AGENDA
PLANNING AND ZONING COMMISSION MEETING
CITY OF CREVE COEUR, MISSOURI
MONDAY, AUGUST 17, 2020
6:30 PM

2. Application #20-024: Amend the Site Concept Plan and Approve a Site Development Plan for a New Outpatient Services Building, Mercy Ballas, at 12120, 12130 Conway Road & 3011 Ballas Road

APPLICATION TO PLANNING AND ZONING COMMISSION #20-023: TEXT AMENDMENT APPLICATION TO AMEND THE ZONING CODE TO ALLOW A DRIVE-THROUGH PHARMACY KIOSK AS A CONDITIONAL USE WITHIN THE PLANNED HOSPITAL DISTRICT

Figure 1: Close-up of the site plan showing the location of the Conditional Use Permit

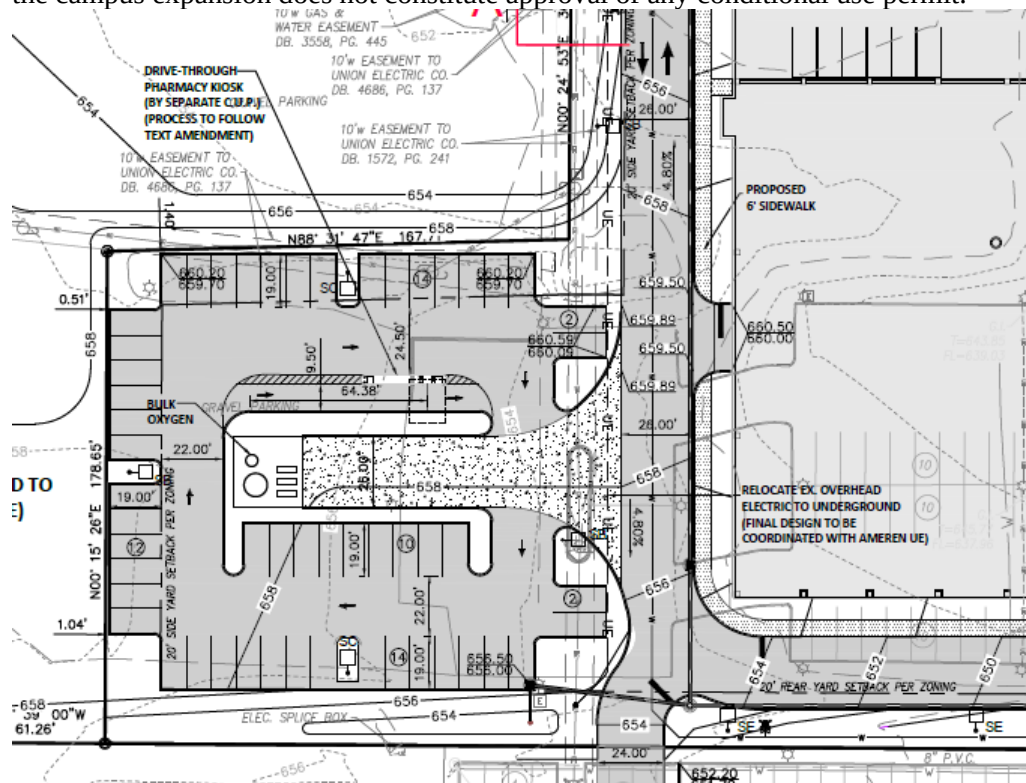
Should the proposal move forward and be adopted, the Applicants would proceed with a conditional use permit request. The Applicants have a pending application for a site development for the Mercy Ballas outpatient center, which shows a potential site for the drive through facility. Approval of the Site Plan for the campus expansion does not constitute approval of any conditional use permit.

Figure 10: Close-up of the south parking garage elevation with the Typical Garage Wall Section.

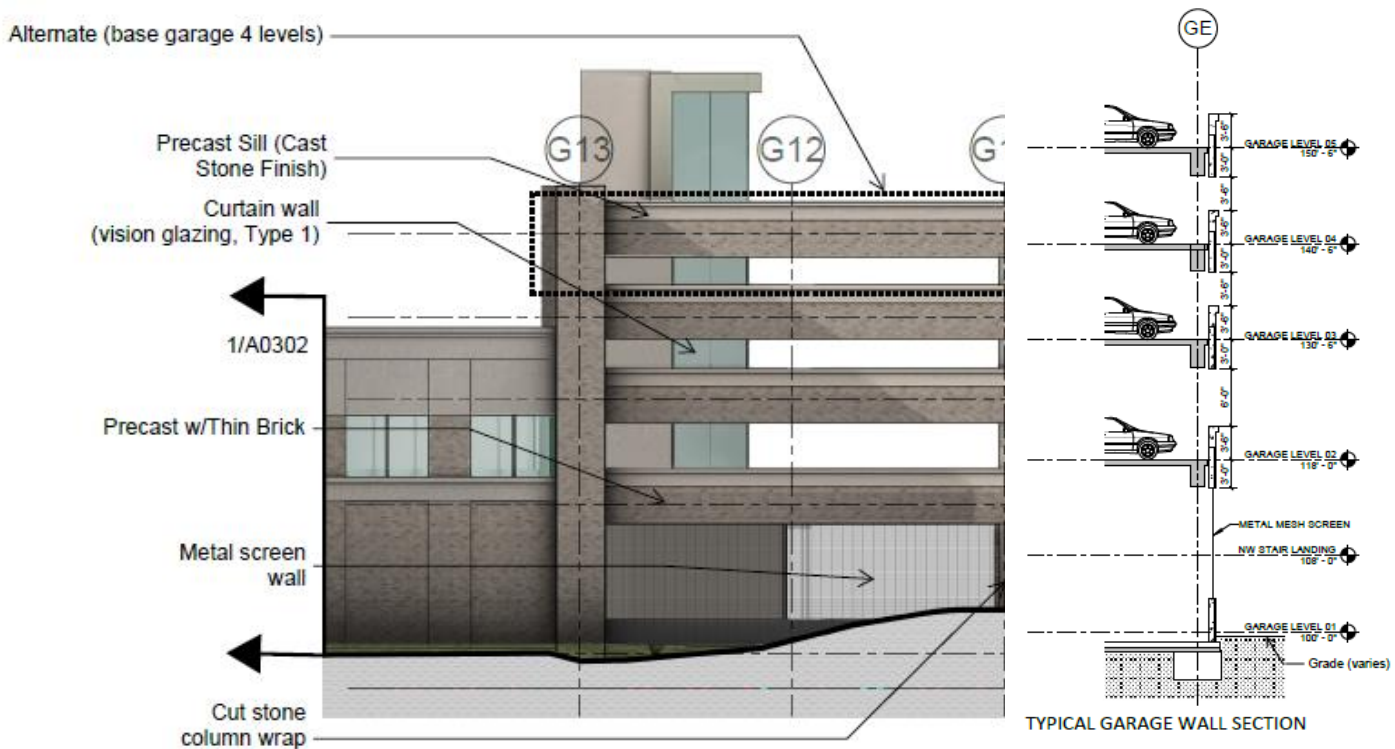
The parking garage structure is designed with the same building material to match the main building, consistent with the Design Guidelines that recommend that accessory structures match the principal building on the site. The garage consists predominately of a thin brick on precast concrete panels, that match the main building, with the cut stone columns on the lower level of the garage and a cast stone sill element similar to that found on the upper floors of the building will be provided at the upper portion of the garage panels. A metal mesh screen wall panels are provided on the lower level of the garage to further screen the loading areas. The Applicant states that the vehicles on the upper levels will mostly be screened from line of sight by the precast wall assembly that are showing at 3.5 feet in height. Staff does have a concern that the parking on the top will be visible for the east bound traffic on Conway Road. Please refer to the garage wall section below.

If the Commission wishes to have greater screening of the vehicles, they will need to discuss the option of increasing the wall height on the top floor with the Applicant, and a condition will need to be included.

Figure 11: Close-up of the site plan of the surface parking area at the southwest corner, with the bulk oxygen tank and enclosure, and Section D-D on Sheet C3.0

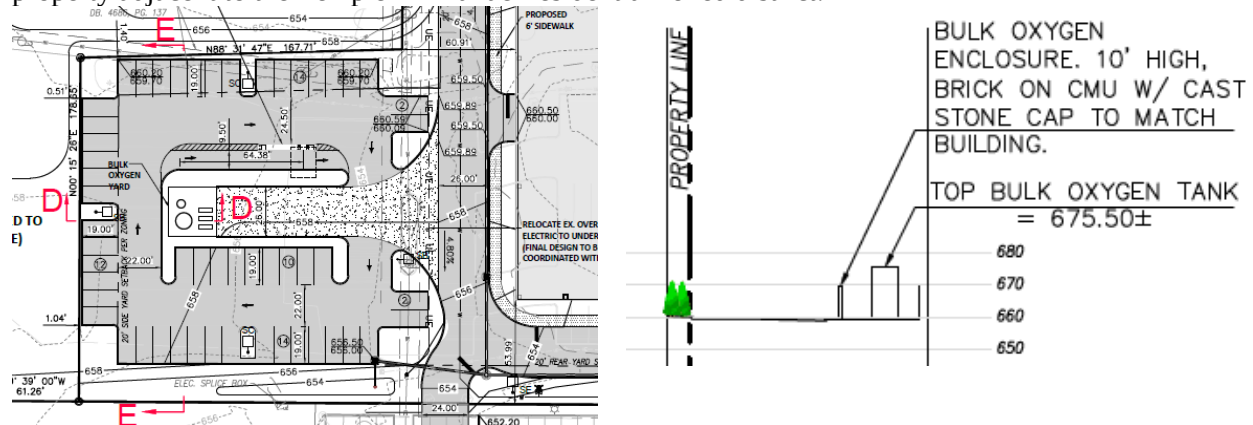
The site plan is showing a bulk oxygen tank within the surface parking area at the south west corner of the property adjacent to the Temple Emmanuel residential zoned district.

Elevations of the tank have not been provided, however, the Applicant has indicated that they will provide a 10 foot tall masonry wall enclosure that will match the building with the same brick for the building on CMU with cast stone cap, therefore, Staff has included a condition for such.

Figure 15: Close-up of the landscape plan showing the Grass Pave fire lane.

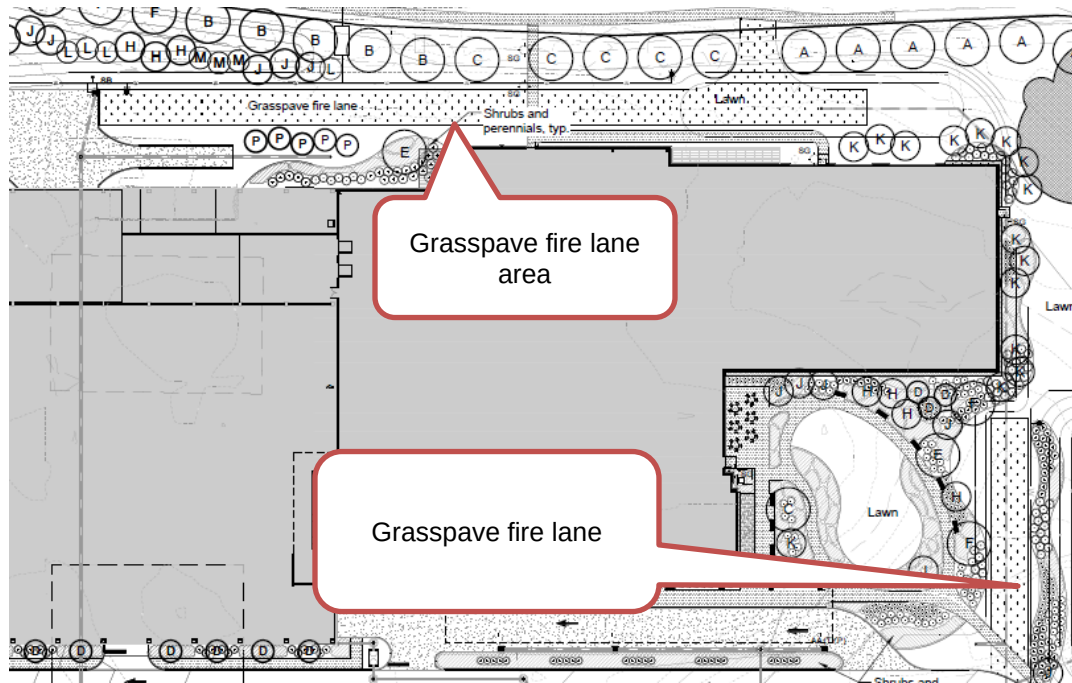
The site plan is showing in the shaded areas the use of Grasspave for fire district access at the north east corners of the building. The intent is that these will remain the look of a green lawn and will only be used for a fire truck in the event of an emergency. The Applicants have discussed the use of the material with the Fire District and District has asked for additional information to ensure that the material will hold the weight of the fire trucks as part of the final review with the permit. The Applicant has stated that the goal is to use the least amount of standard concrete/asphalt paving while accommodating the needs of supporting the 78,000 lb. vehicle loading of the fire truck, but that further detail will be reviewed as part of the permitting phase with the Fire District. The limits of the fire lane shown on the drawings have been accounted for as impervious area in the site coverage calculations. A condition of approval includes that signage prohibiting parking in this area will be necessary and to ensure that it remains the appearance of a green lawn to the extent possible to comply with the Creve Coeur Fire Protection District.

Figure 17: Close-up of the Site Concept Plan of the Pedestrian connection from the 2018 on the left, and a close-up of the current plans of this area on the right.

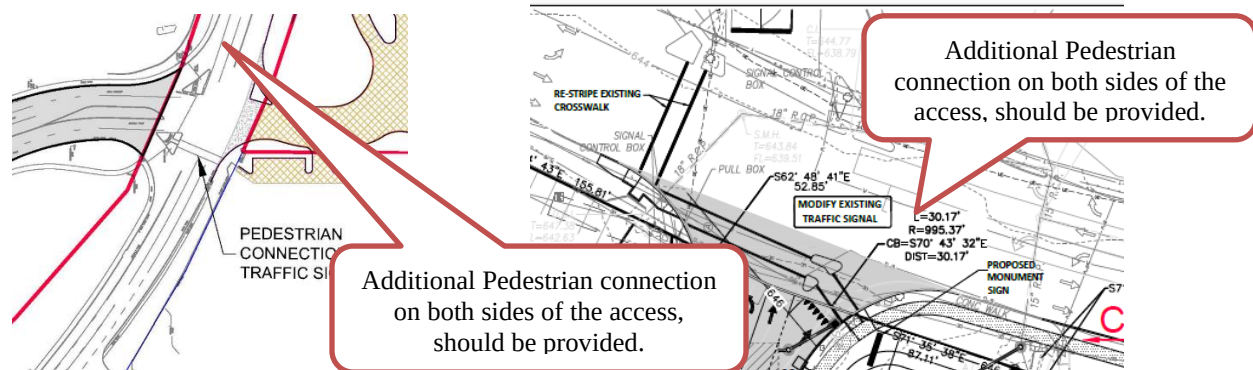
As part of the 2018 report, Staff recommended that additional pedestrian connection to the lighted intersection of the main entrance connecting the north and south campus area be provided on the east as well as the west side of the entrances, which would be located closer to the building.

Therefore, Staff has continued this condition within the recommended conditions of approval for the development.

Figure 18: Close up of the Applicants Photometric Plan at the South property line, showing the light spillage along the internal drives.

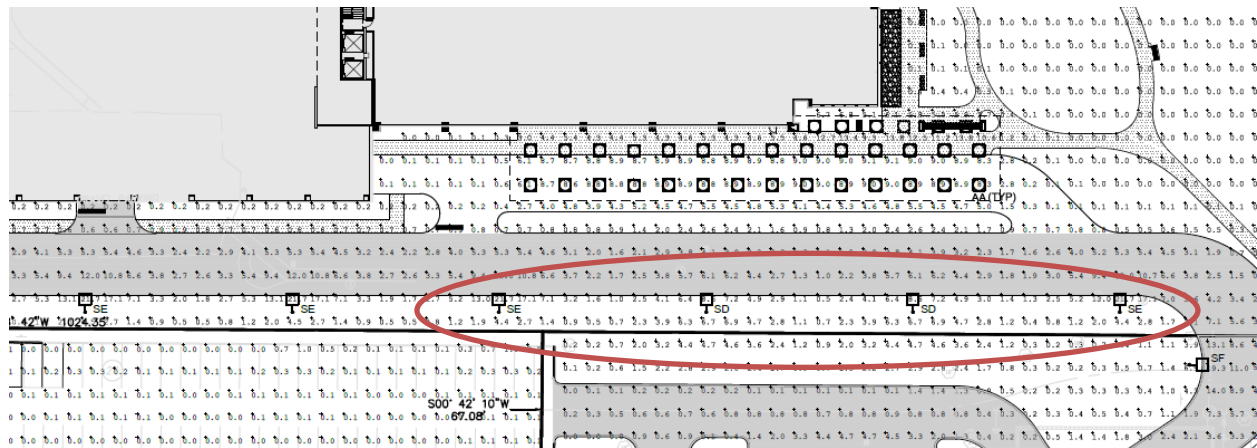
The proposal include lighting that is consistent with Section 405.680 Lighting regulations of the Zoning Ordinances. The Applicant's photometric plan indicates that all lighting is downcast with only limited spillage up to 6.9 cf. at the south property line/Town and Country boundary line, adjacent to the commercial parking areas the remaining South Campus area.

The lighting is LED and downcast and will have a maximum mounting height of 20 feet, where Section 405.680 allows for a maximum height of 24 feet for properties within non-residential districts. The lighting on the top deck of the garage will be lowered to the 12 foot in consideration of the overall height of the structure.

Figure 14: Close-up of the Site Concept Plan of the Pedestrian connection, Staff recommends that an additional connection be provided to the north

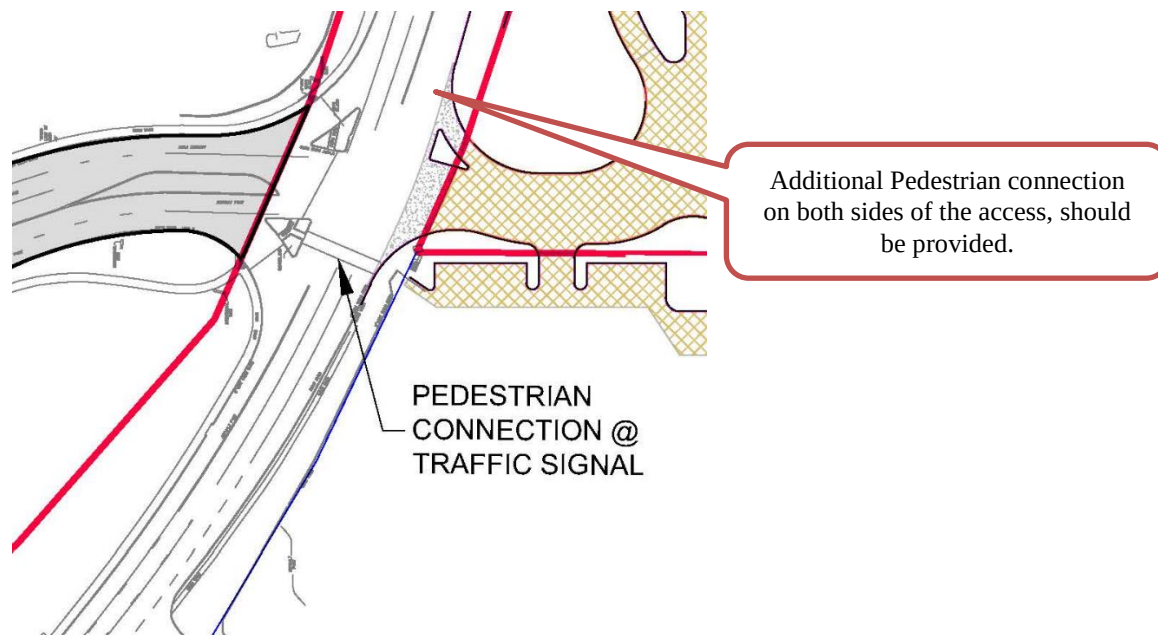
Additionally, Staff recommends that additional pedestrian connection at the lighted intersection of the main entrance connecting the north and south campus area be provided, which would be located closer to the building.
